Response to Queries raised in Module 1\* of  
the N6 Galway City Ring Road  
Oral Hearing

Aebhín Cawley & Andrew Speer - Biodiversity  
John O' Malley – Planning  
Dr. Leslie Brown and Catherine Buckley - Hydrogeology  
Juli Crowley – Soils and Geology  
Eileen McCarthy - Engineering

**10 March 2020**

**Plate 4: Habitats at the Proposed Drainage Outfall from the N59 Link Road North (Fossitt Code)**

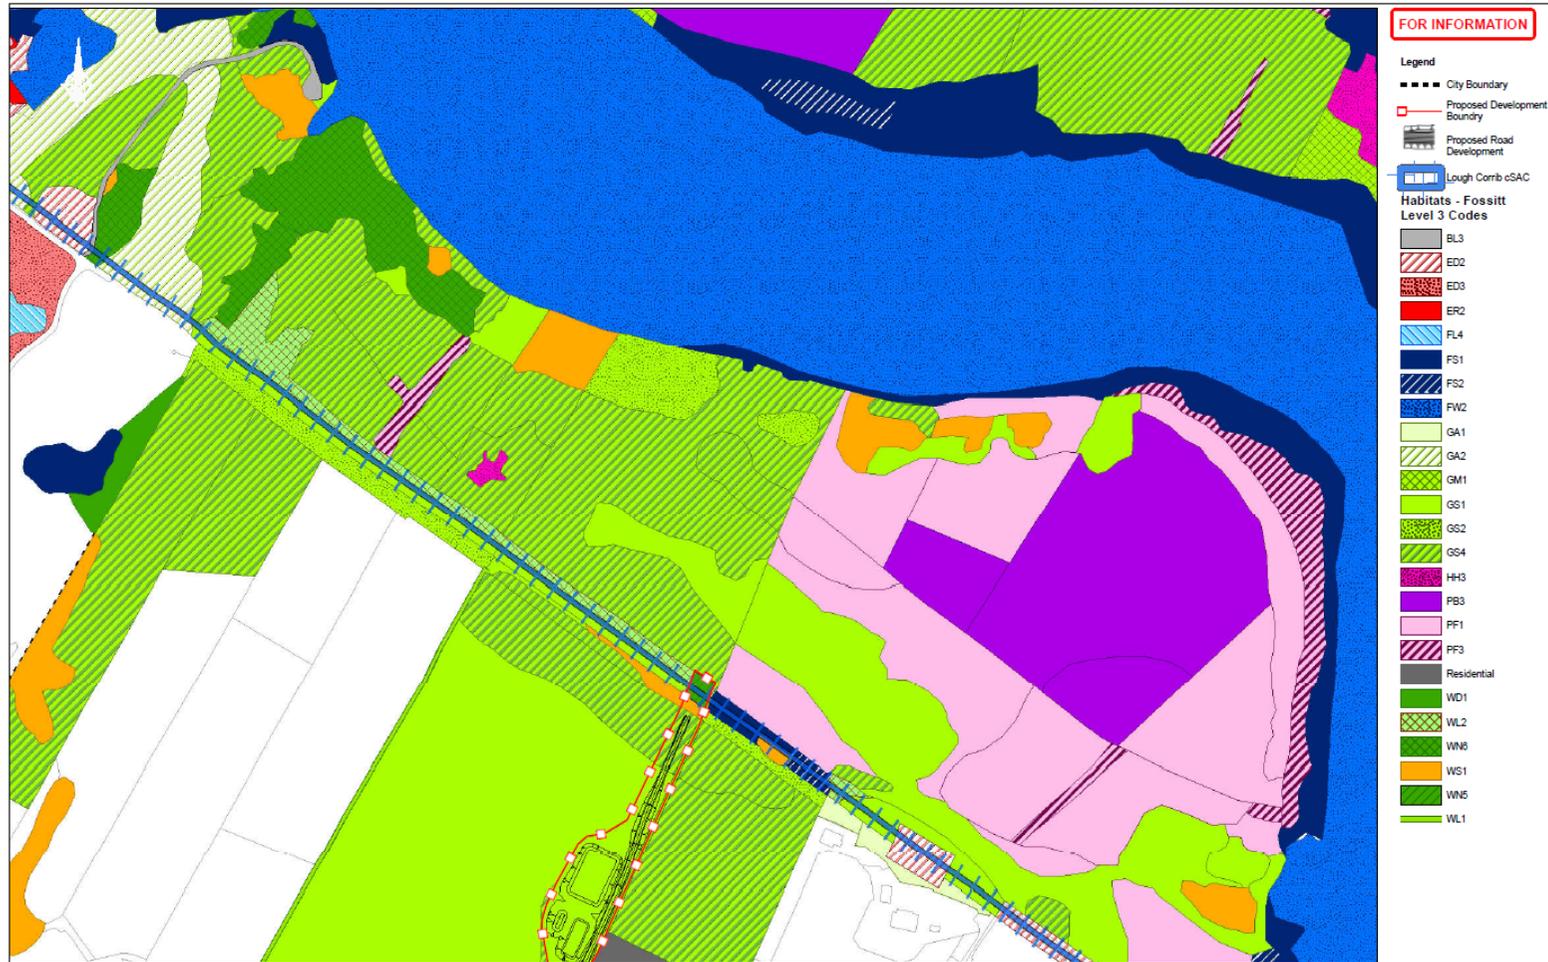
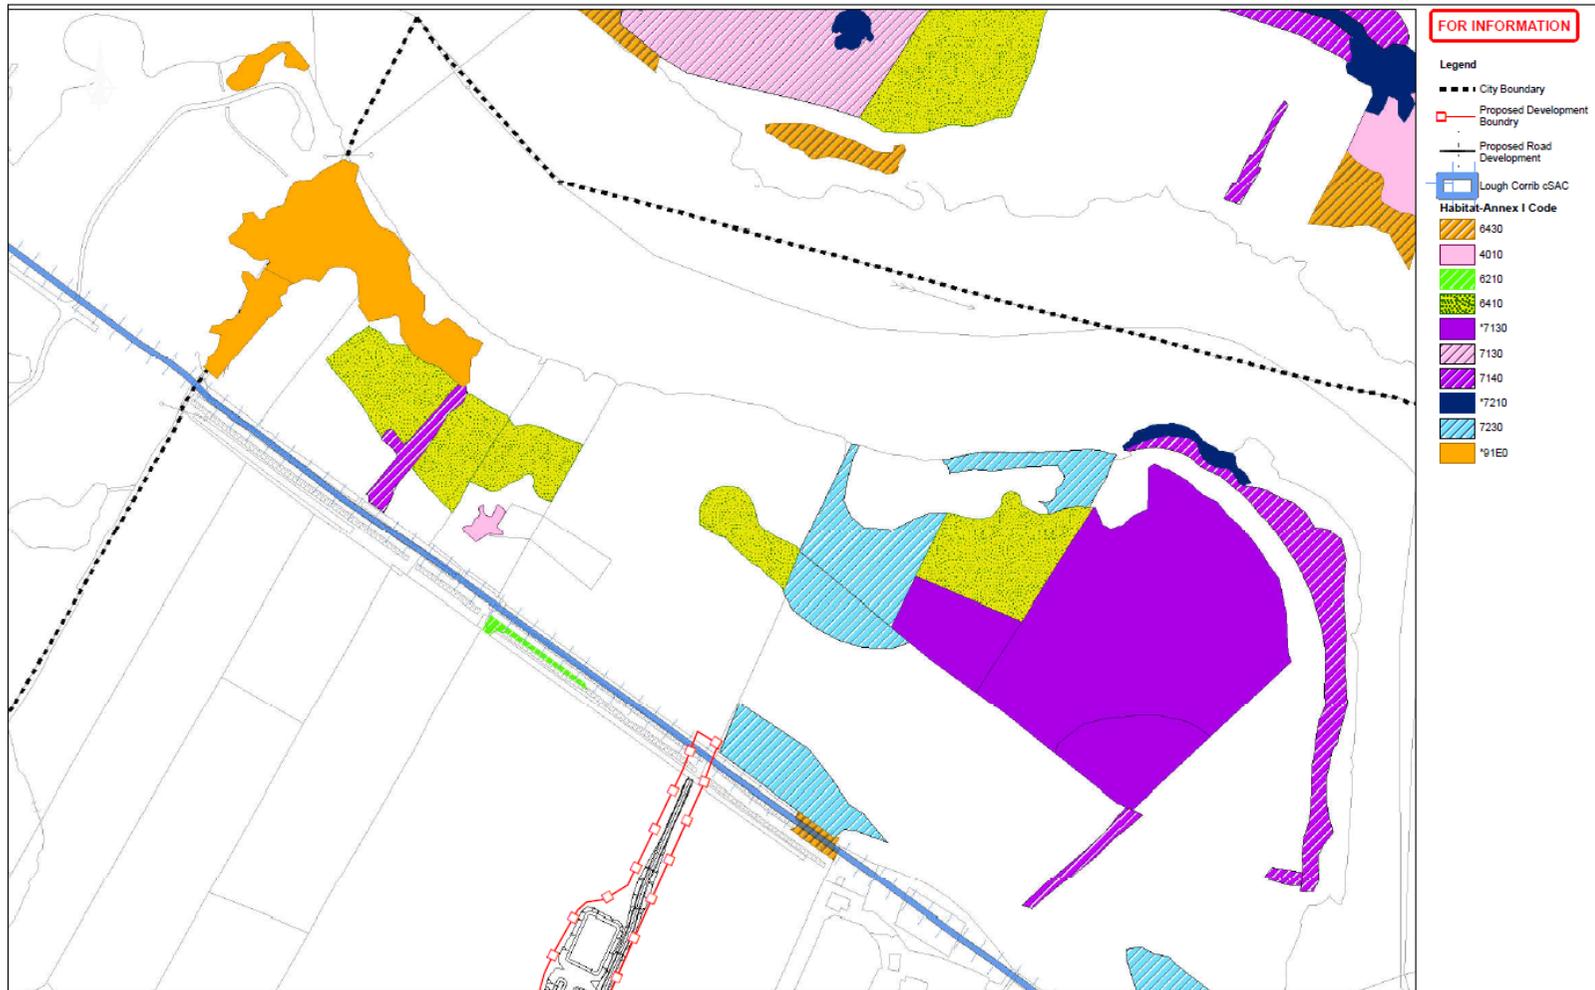
**Mr. Arnold requested clarification on whether the habitat maps referred to in Section 4.6 of the RFI Response (Figures 2.8.01 and 2.8.02 in Annex II to Appendix A.3.1 of the RFI Response) were incomplete.**

It is confirmed that Figures 2.8.01 and 2.8.02 in Annex II to Appendix A.3.1 of the RFI Response document are not incomplete. Rather, the figures demonstrate two distinct subsets of the overall habitat map in response to the specific question asked in the RFI, i.e. to *“Provide additional information on habitats/vegetation within the cSAC from the point of the outfall to the River Corrib, including for the drainage ditch and the vegetation located on either side (minimum 25m) along its full length.”*

Thus, in conclusion on this point, the habitat mapping is not incomplete. The habitat areas shading on Figure 2.8.02 in Annex II to Appendix A.3.1 of the RFI Response are areas of Annex I habitat. The non-shaded areas in that habitat map correspond with non-Annex I habitat type areas

For the avoidance of doubt, a composite map displaying all habitat survey results from 2018 and 2019 is provided in Plate 4 (Fossitt Code, i.e., non-Annex I habitat areas) and Plate 5 (Annex I Code) below.

**Plate 6: Mammal Passage Facilities****1.8 Use of Underpasses by Common Lizard**

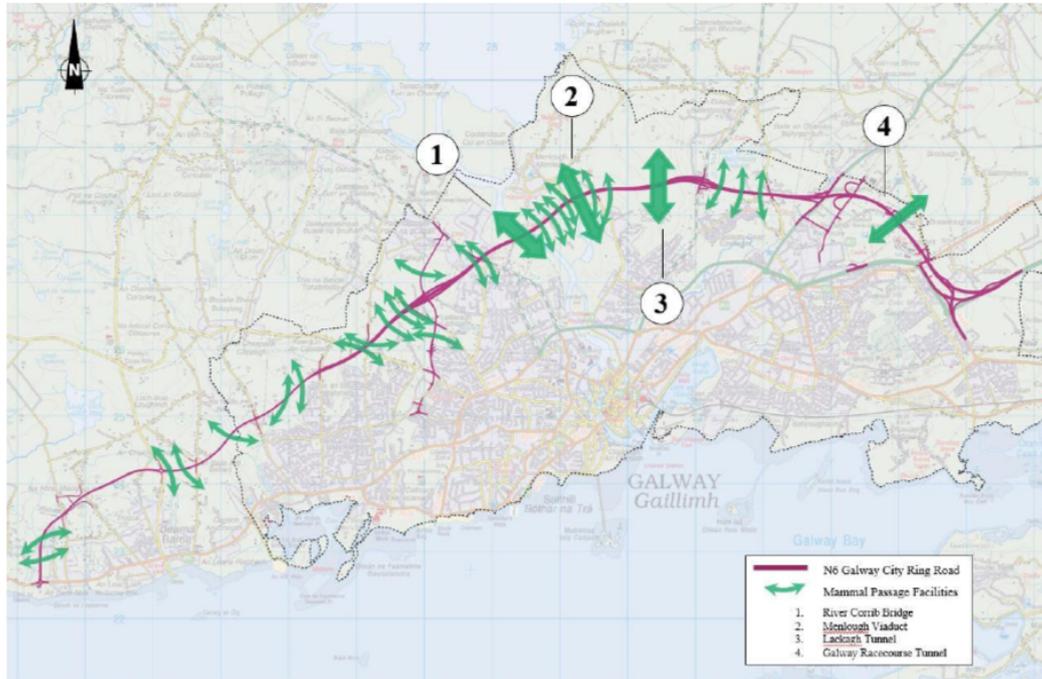
**Mr. Arnold requested clarification on where design details of the mammal passage facilities were provided in the Applicant's documentation.**

Table 8.36 of the EIAR sets out where dedicated mammal passage facilities will be provided in terms of: target species, location, type of structure and reference number, and dimensions. This table is reproduced below in Table 2 with reference included to the specific drawing for each mammal passage facility and a copy of each drawing included in Appendix A for ease of reference. Drawing GCOB—500-D-520 has been updated to the top water level and the otter ledge 200mm above the flood level.

Plate 4.11 in Section 7.1 of the RFI Response (reproduced below in Plate 6) illustrates the locations of all mammal passage facilities across the proposed road development.

**Plate 7: Example of the triangulation net used**

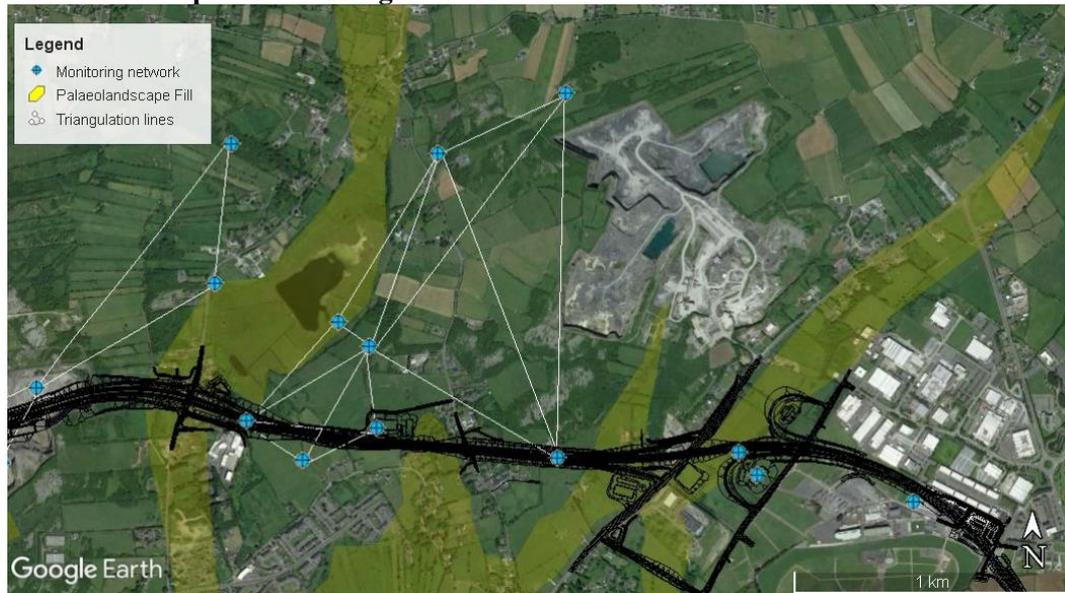
## 2.1.3 Questions regarding hydraulic gradients

Hydraulic heads away from the centreline were used to triangulate the regional groundwater gradient and flow direction. A triangulation net was constructed across limestone groundwater bodies to provide a comprehensive assessment of gradient and flow direction. This allowed hydraulic gradients between monitoring points to be calculated and used to plot groundwater contours beyond the centreline and in the wider extent of the aquifer. The groundwater monitoring network allows groundwater flow directions to be calculated. An example of the triangulation net used is presented below in Plate 7.
